PROPOSED DISTRICT STRUCTURE PLAN, VARIOUS LOTS FOR NORTH ELLENBROOK WEST, CITY OF SWAN

DPLH COMMENT RESPONSES

TIA ADDENDUM 1

20.07.2022

Figure 1: District Structure Plan

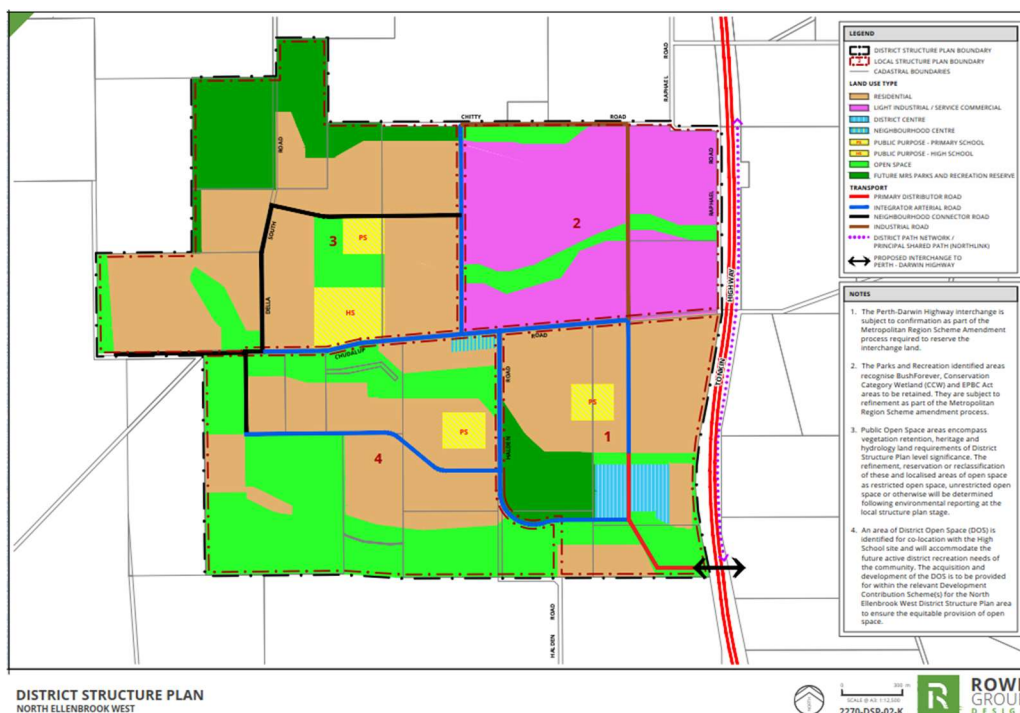
A query was raised regarding the trip-making to schools in the district structure plan (DSP) area and how traffic is addressed in the modelling.

Four schools are identified in the area; three primary schools and one high school. There is one primary school in each of the residential local structure plan areas (see **Figure 1**). The high school is in the north west local area (Zone 3).

Traffic to schools in the TIA is not explicit but is contained within the trip generation assumptions. Residential trip rates are assumed as 9 vehicle trips per day per residence and includes trips to schools. Also, the modelling assumes that 55% of all residential trips remain within the structure plan area with 30% of these going to the industrial/commercial area, 60% to the district centre and 10% to the neighbourhood centres.

The impact of these assumptions is to overestimate traffic on the major roads, as some of the generated traffic would be local traffic to schools, traffic which in practice would use local roads (not included in the network); the modelling assumes that all traffic is assigned to the major road network. This is considered a conservative but appropriate approach when the network or zoning is not sufficiently refined to reflect the local catchment of each neighbourhood. This is especially true of primary schools which tend to have a very local catchment. In effect, the 55% of home-based trips which remain in the Structure Plan area would include local trips (including school trips). Similarly, the 45% of home-based trips which are assumed to leave/enter the area would include some school trips from outside the Structure Plan area, should the schools attract external students or staff. It is not possible at this stage of the planning process to identify if any of the schools are likely to have a broader catchment.

DVC acknowledges the advice in draft Operational Policy 2.4 Section 3.5 Movement Network. DVC considers the current locations representative in that they occur in each of the four main local structure plans. Again, as more definition emerges with refined planning, the schools' locations will be reviewed and modified to ensure compliance with Policy 2.4.

Figure 3: Base Model Screen Line Comparison

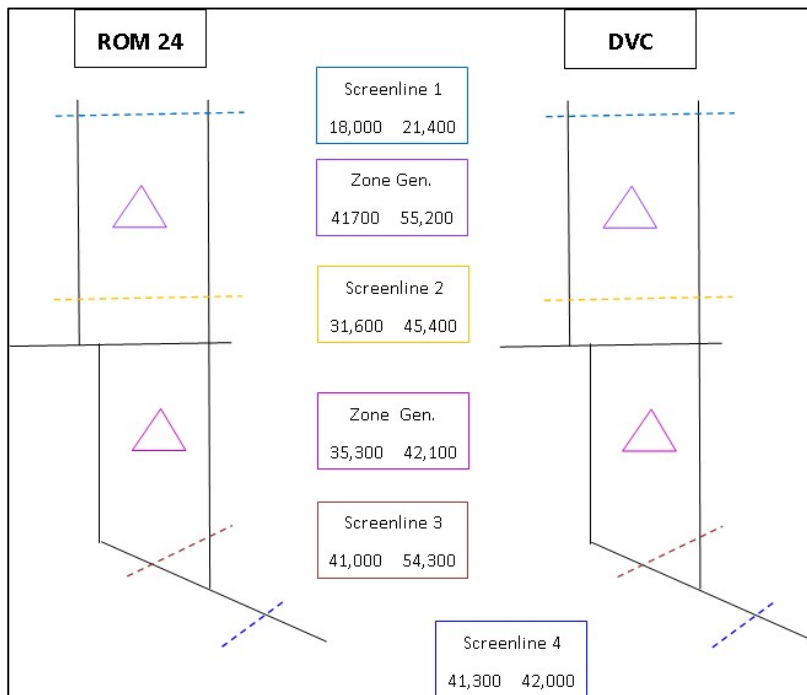
A question was raised about the differences between the DVC modelling and ROM modelling. DVC was provided with the ROM24 (ROM) assignments for 2041 but no other details such as select link data. From the data available some obvious differences are apparent, i.e. the zoning system and road network are disaggregated and detailed in the DVC modelling. The trips generated in the area also differ, with the DVC model generating more trips. The following sections explain these differences and show how logical and reasonable adjustments to the DVC model could bring the outputs closer.

A comparison of selected screen lines is shown in **Figure 3**. SC1 to the north compares well, as does SC4. These represent the key internal/external interfaces for the DVC model. The comparison differs markedly for the screen lines internal to the DVC model area. We are aware that the location of the District Centre will focus trips there in the DVC model. In the ROM model it is presumably included in Zone 1462. Also, we feel that access to the industrial zone will be from several east-west roads off Road 1. The location of the southerly zone connector in the ROM model is most-likely misplaced.

Figure 5: Proposed Road Hierarchy

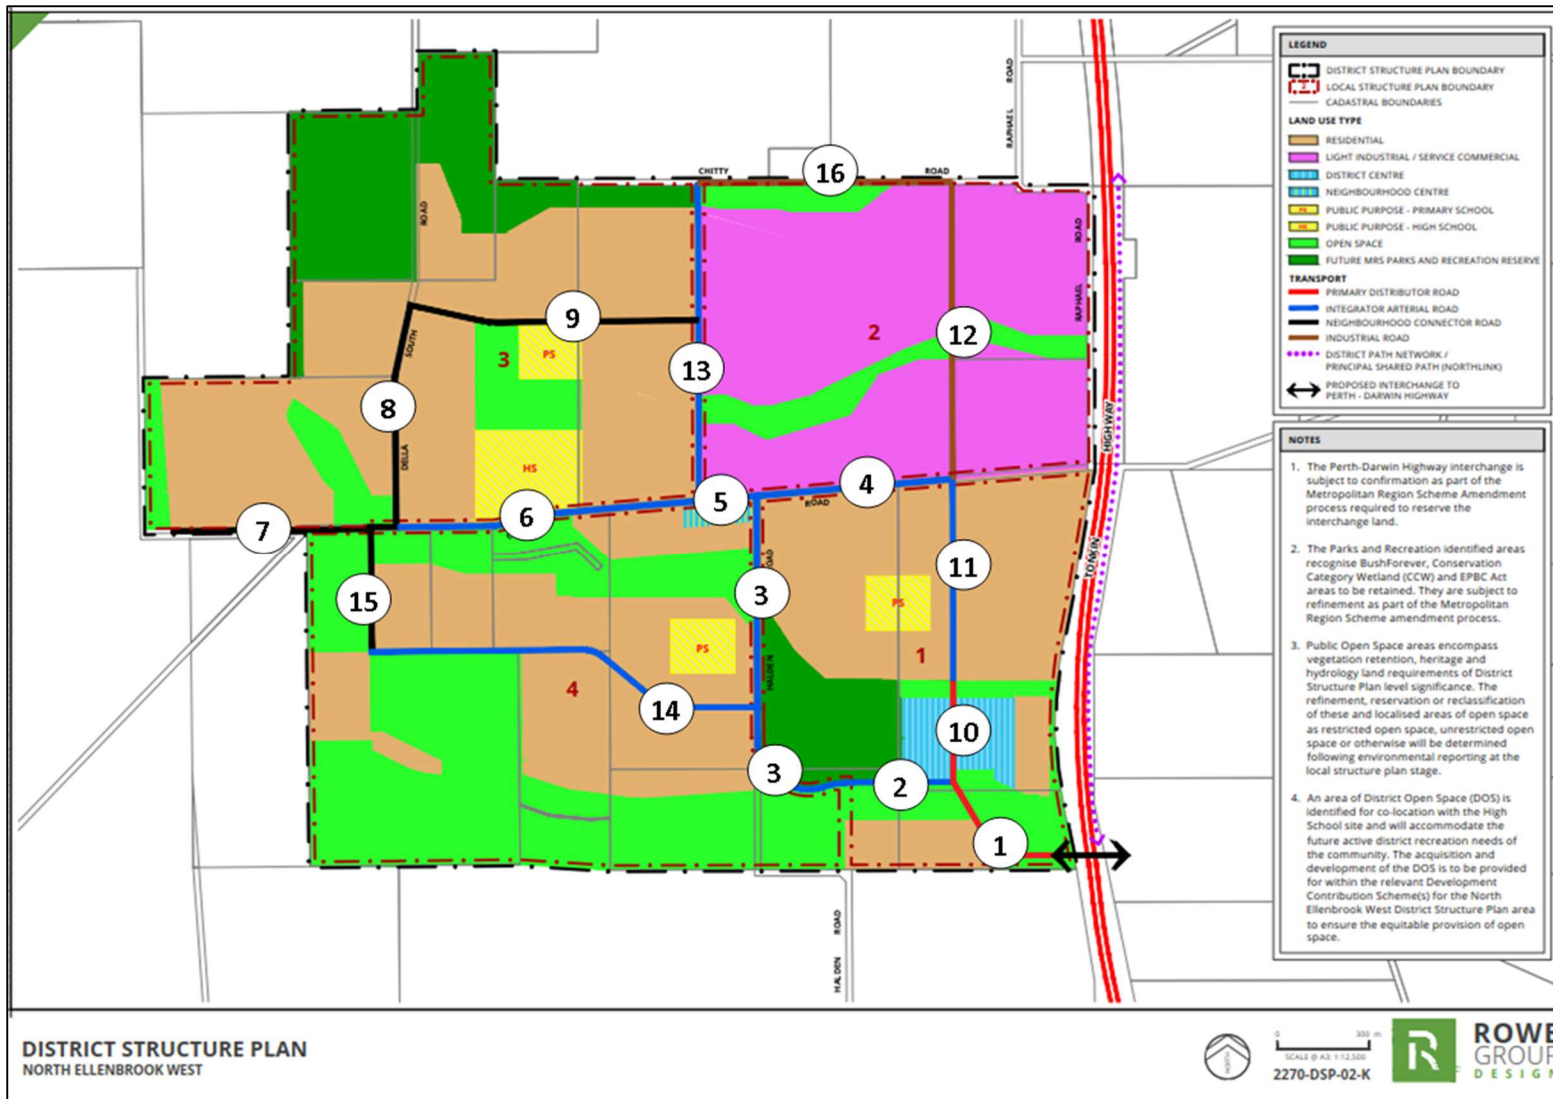
The revised structure plan road network for the Ellenbrook North West area is represented in **Figure 5**. The Department has also provided recommendations on the proposed road reserve widths. These recommendations have been adopted on the assumption that modelling and road reserve widths will be reviewed at subsequent stages of planning i.e. the local structure planning stage. Based on this and the revised assignment discussed above, the recommended road reserve widths are shown in **Table 3**.

Chitty Road lies on the northern boundary of the Structure Plan area and was not included in the TIA modelling. If it were included as part of future planning it is likely to function mainly as a connection between Road 1 and Road 2 and provide access to internal access roads. According to Development Control Policy 4.1 for industrial subdivision, highly trafficked industrial road carriageways should be 10m wide within a road reserve of 25m. The proposed 25m road reserve allows two 5m wide traffic lanes and 7.5m wide verges on each side.

Della South Road was also not extended further north in the Structure Planning area than shown in Figure 5 as this extension was not contemplated under the Bullsbrook Freight and Industrial Land Use Planning Strategy as part of the primary transport network. Also, the land directly north of Della South Road is a Bush Forever Reserve under the Metropolitan Region Scheme which does not provide a direct connection into the planned industrial area.
